## New Replacement Gauge Instructions

Picture 1

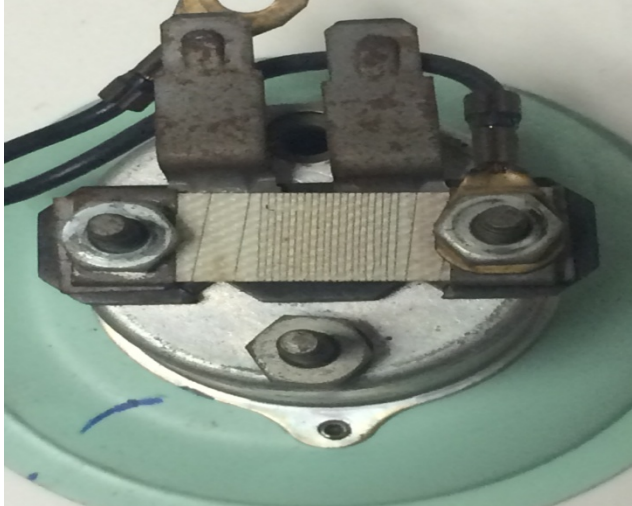
New reproduction small electric gauges for the 1965-1982 Corvette do not require the use of the small resistor band as original. (Picture 1)

The electronics inside of the new gauges have been updated to current technology. Because of the new electronics there is no reason to install the resistor as the gauge was originally installed.

All other wiring connections and mounting points are exactly the same. You will not burn up your new gauge if you accidentally have re-used the resistor but the gauge may not show the correct calibration when the resistor is installed.
